Response to request for information memo

Tilbuster Solar Farm

February 2022

Project Number: 20-729

Figure 4-6 'No impact zone' east

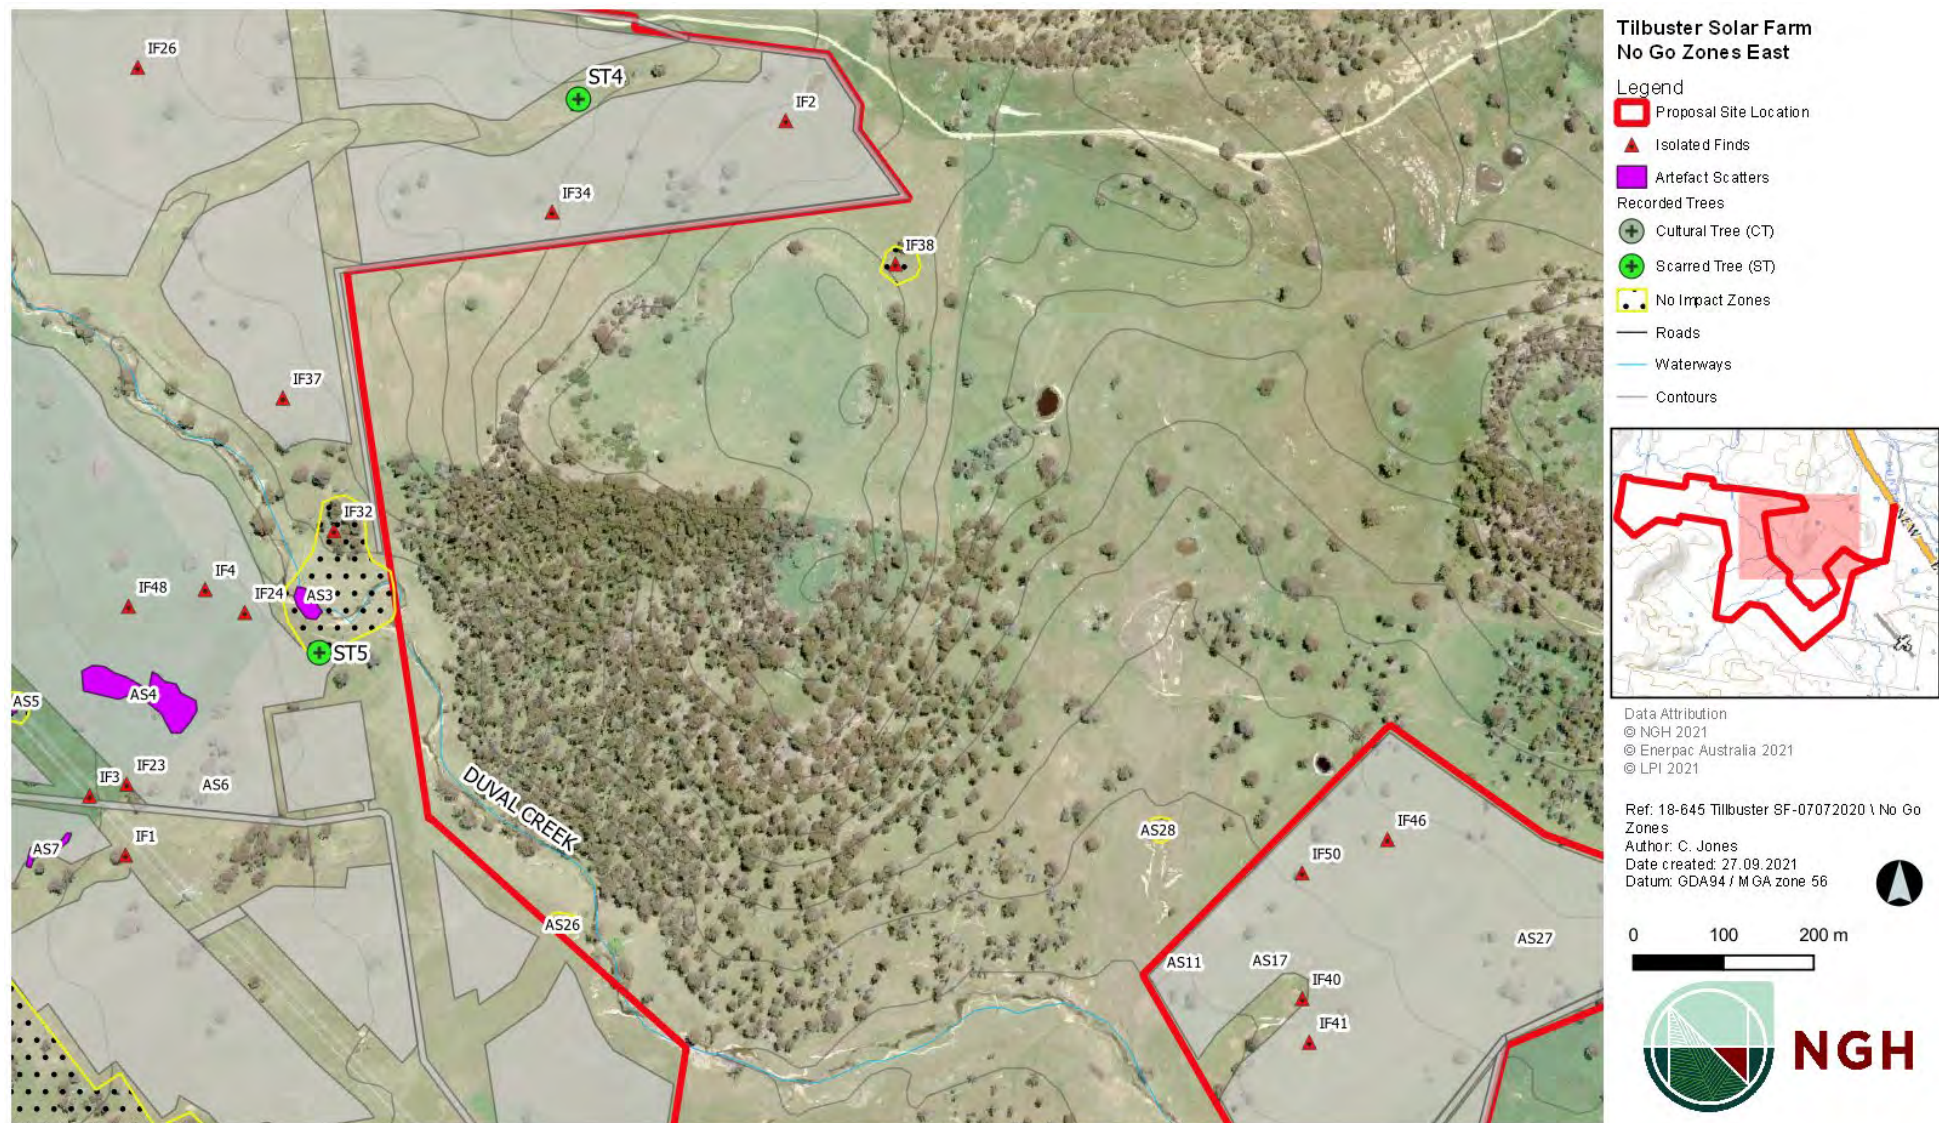
1. Refer to the latest VPA offer between Enerparc and Council.
2. Aboriginal Heritage:
 - Clarification regarding the indirect harm to some scar/cultural trees has not been provided. Heritage NSW opposes any harm to any culturally modified or culturally significant trees.

2. There are 15 'no impact zones' within the Development Site as shown in Figure 4-2 to Figure 4-6. These must be fenced or otherwise clearly delineated and included in all onsite inductions and management plans. The development should avoid any direct or indirect impacts to the sites located within these 'no impact zones'.

Figure 5-1 Vegetation zones for biodiversity management

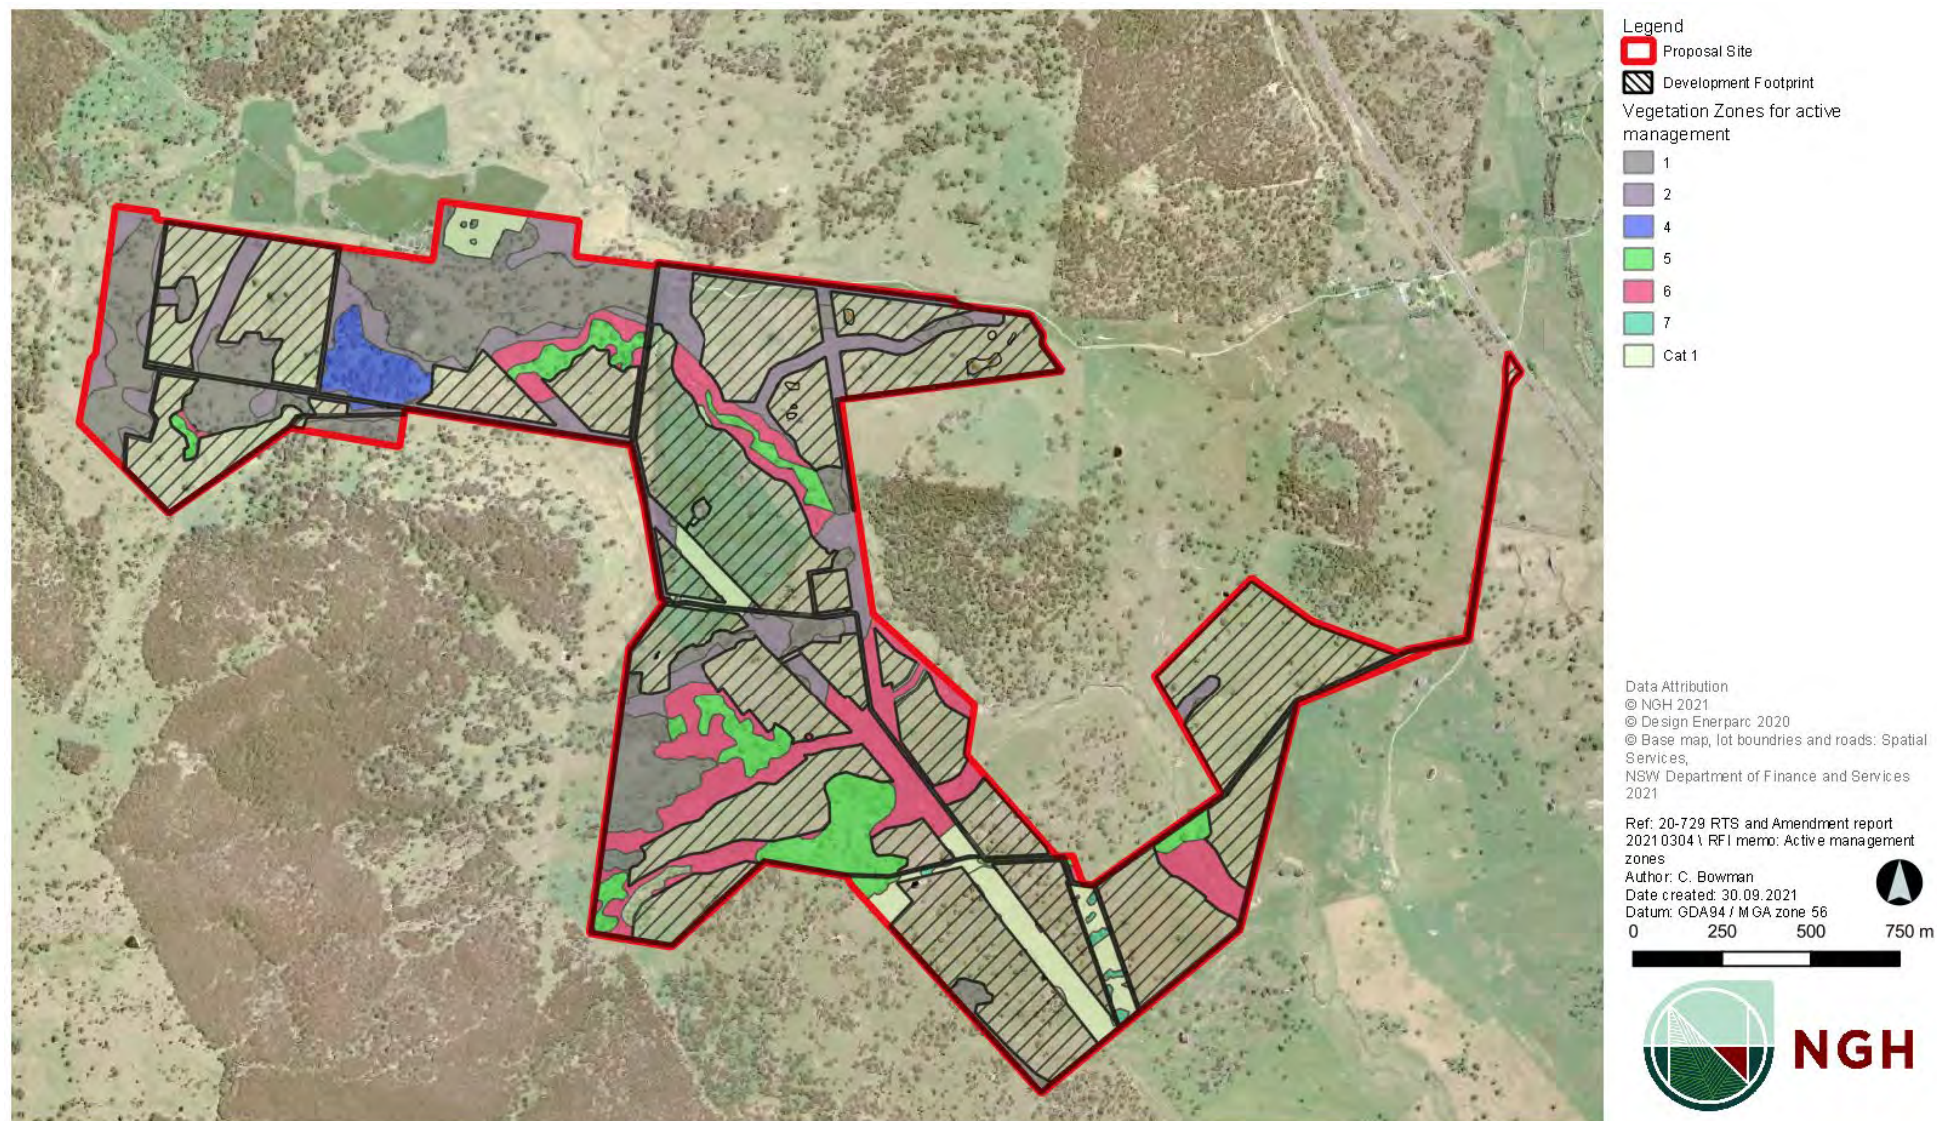
3. Layout plan:
 - Include Essential Energy transmission line
 - Include surrounding receivers out to at least R1
4. Constraints map:
 - Zoom in to same scale as Figure 5-1

Specifically, biodiversity adaptive management would be undertaken in the vegetation zones shown in Figure 5-1. These vegetation zones correspond to Table 8-3 of the BDAR v1.4, with specific management actions to be undertaken in each management zone.

Appendix B Development footprint comparison map

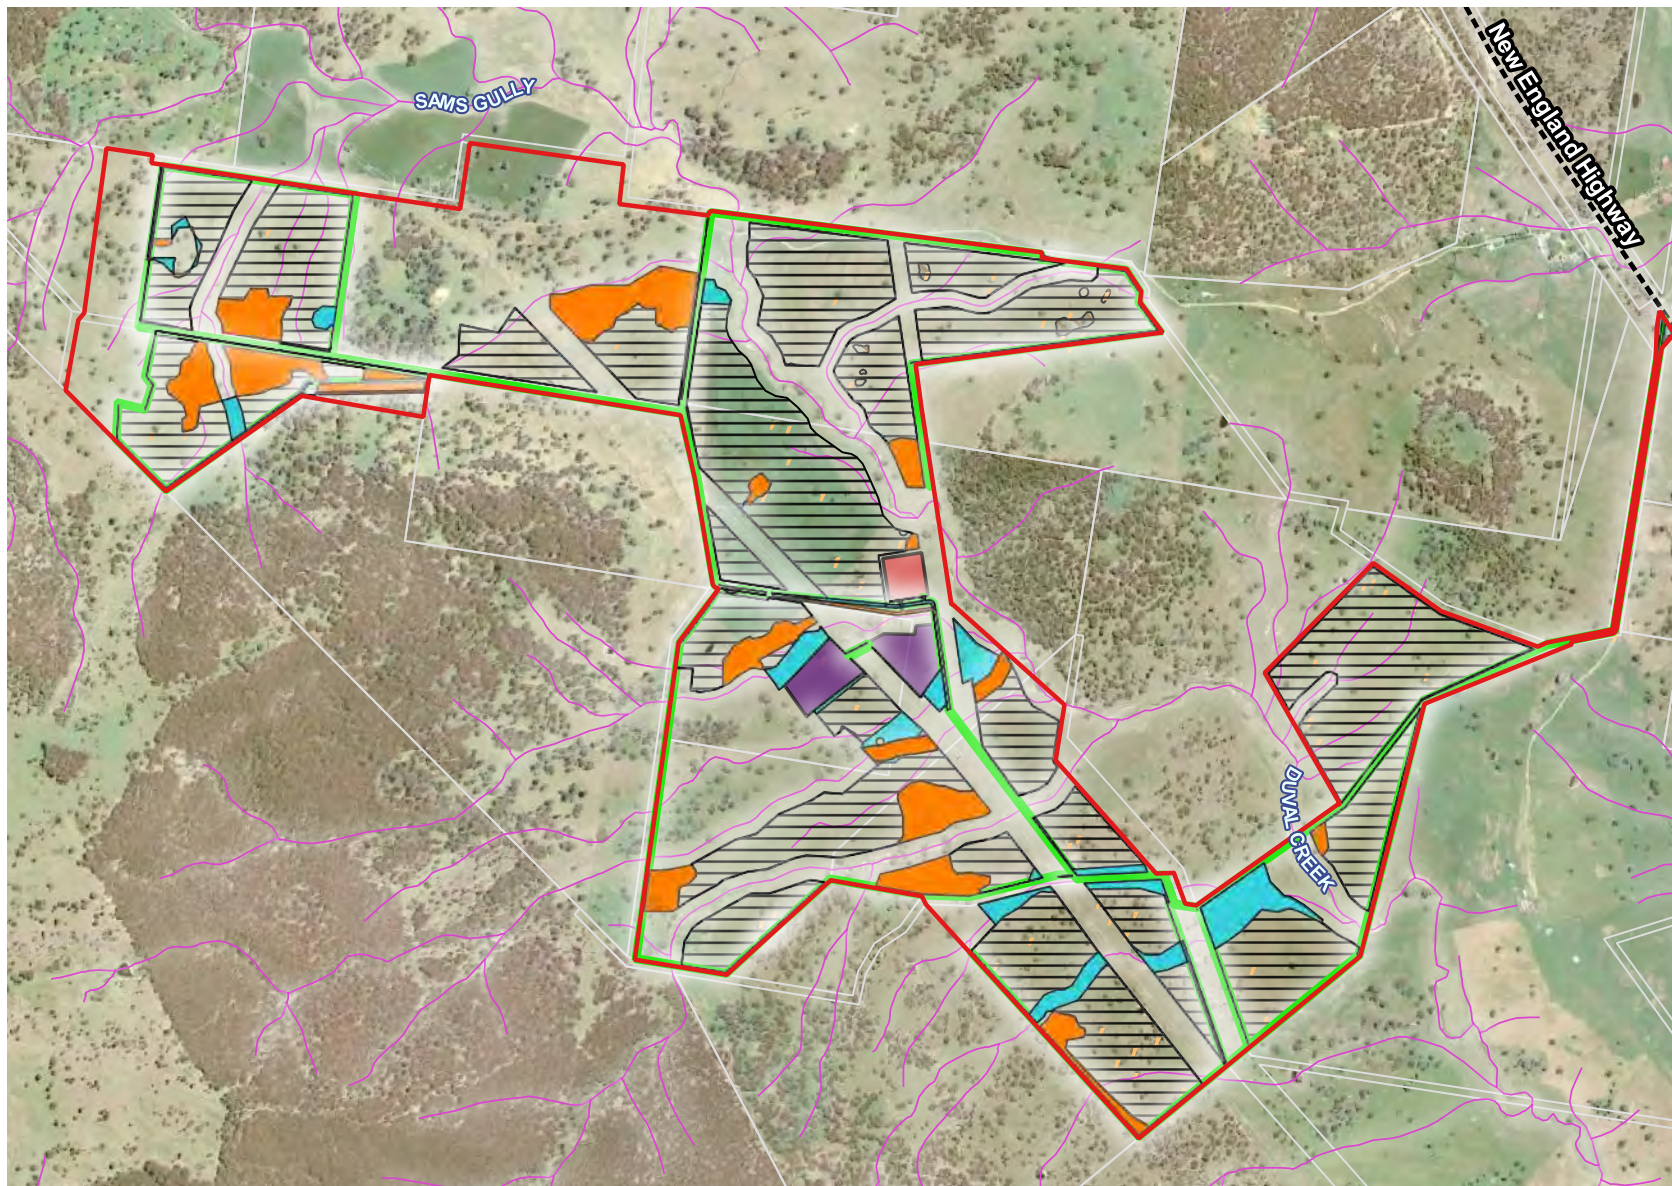
- Provide an amended figure (Figure 4-3 in the Amendment Report), reflecting the current development footprint.
- Provide an amended figure (Figure 8-1 in the EIS), including all receivers and viewpoints.

DPIE requested that Figure 4-3 in the Amendment Report be updated to reflect the current Development Footprint. The updated map which shows these changes is presented in Appendix B.

Figure 1: Locations of Receptors

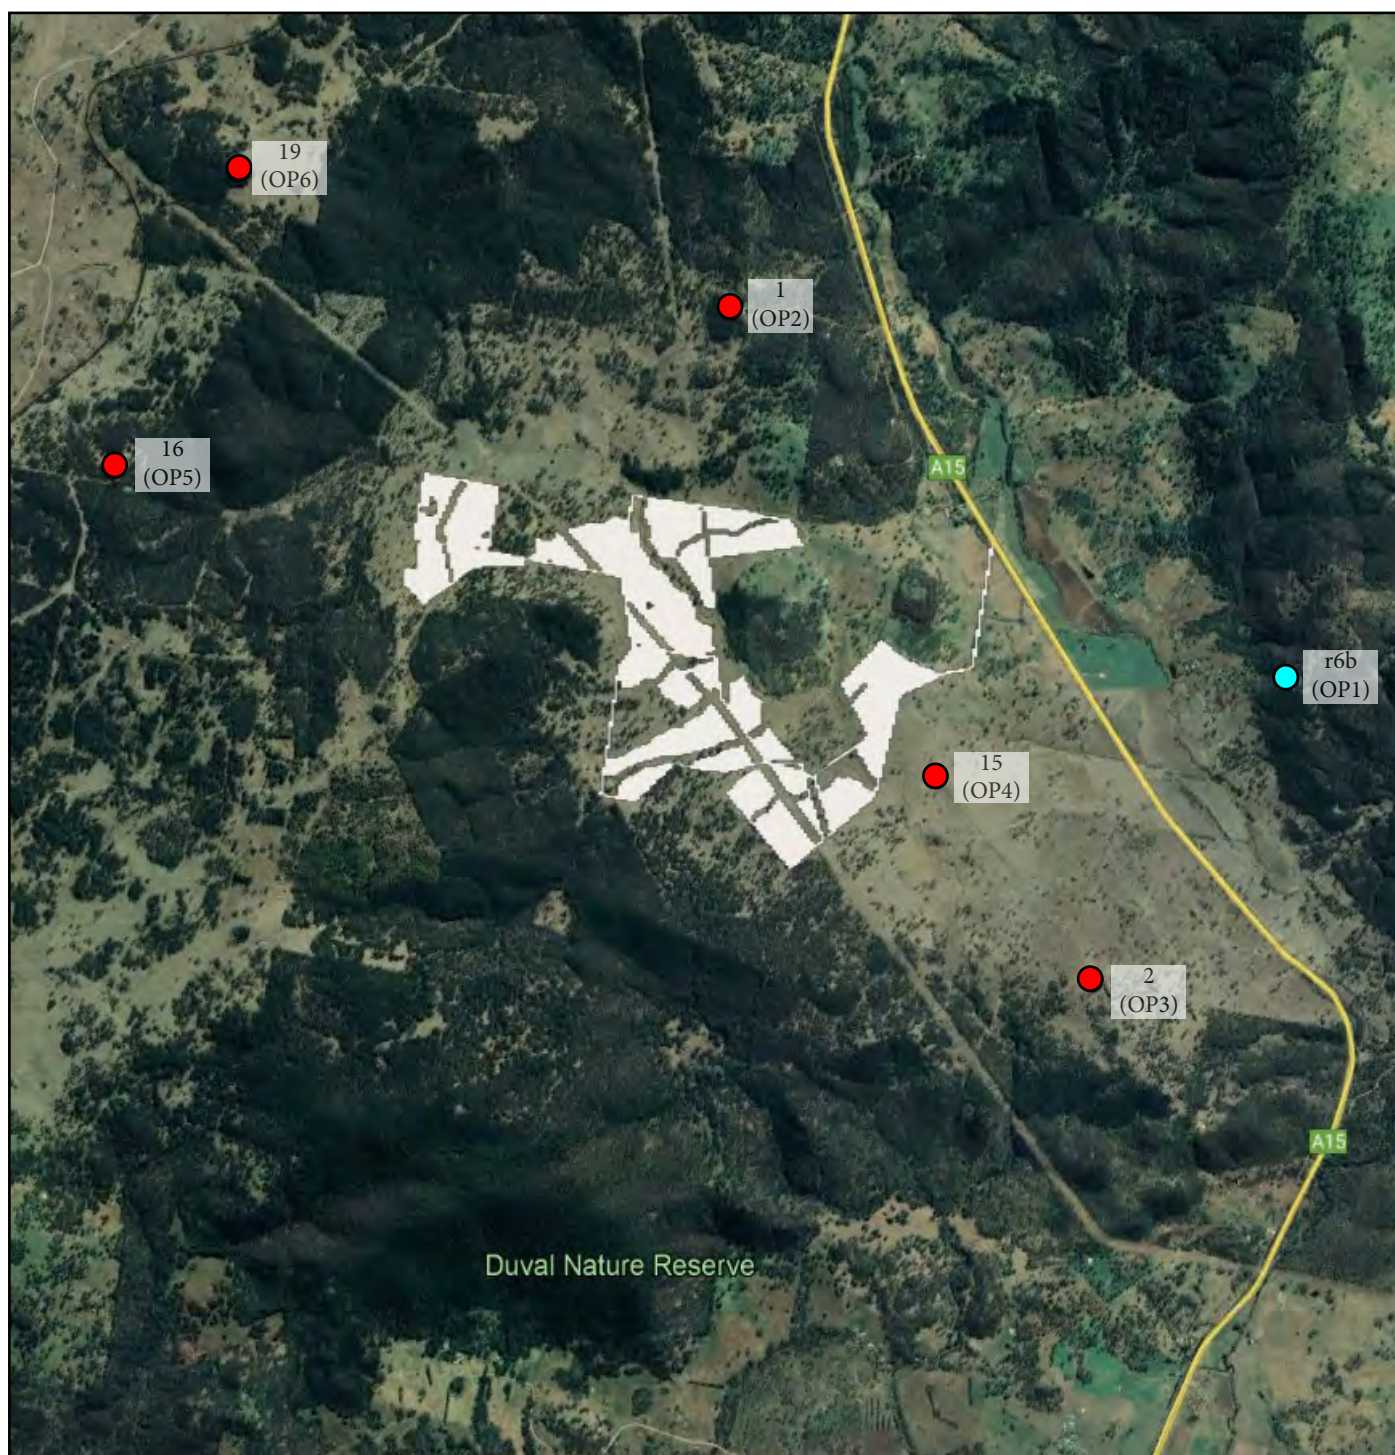
- Reword section 3.1 of Appendix E justifying the selection of receivers assessed. It was previously noted that it is the proponent's assessment, rather than the Department identifying certain receivers.
- In relation to potential glare for specific receivers, clarify the times of the year and the times during the day that glare would be experienced.
- Indicate which panels sections would cause glare to be experienced by receivers.

Six (6) sensitive receptors have been identified by the **proponent** potential visual receivers within 2500 metres of the Project. Potential glare was assessed along five (5) residential receptors within close proximity of the Site and one (1) public receptor (r6b). The SGHAT tool was also used to assess potential glare of the 6 receptors next to the site. Refer to **Figure 1**.
